To: County Commissioners

From: Paul E. White, 6390 Cove Road

Re: B&J Preliminary Plat (LP-08-21)

Soil Survey

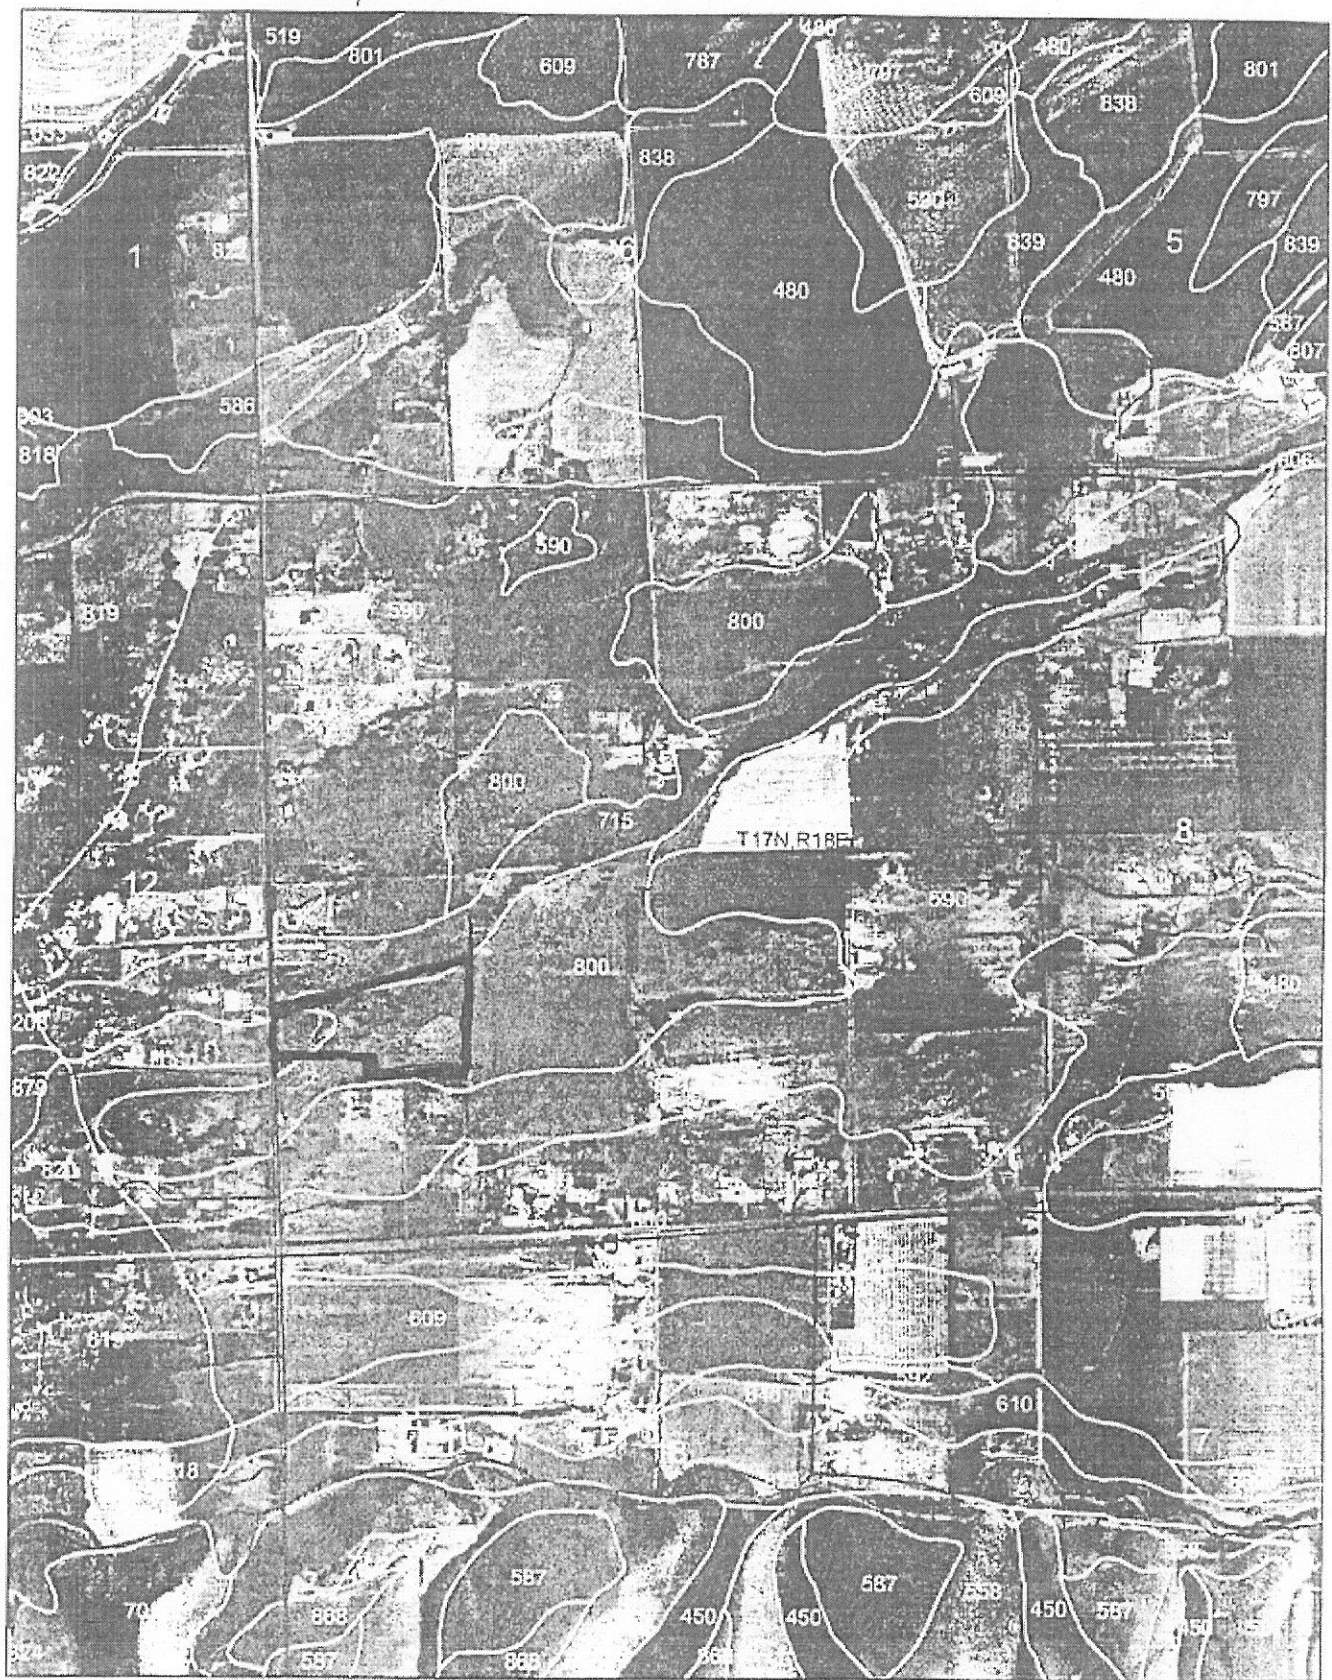
In truth, based on the findings of the USDA Natural Resources Conservation Service Soil Survey (See Attached Documentation), this development would have a significant impact. Enclosed is the map showing the Duncan Rezone with a soil classification of 800 (Brysil gravelly ashy loam). This classification by the USDA is considered **Prime Farmland**. This is a quote from and is included in the documentation I received from the USDA: "A recent trend in land use in some areas has been the loss of **prime farmland** to industrial and urban uses. The loss of **prime farmland** to other uses puts pressure on marginal lands". These two statements are in agreement that **prime farmland** should be protected from "development".
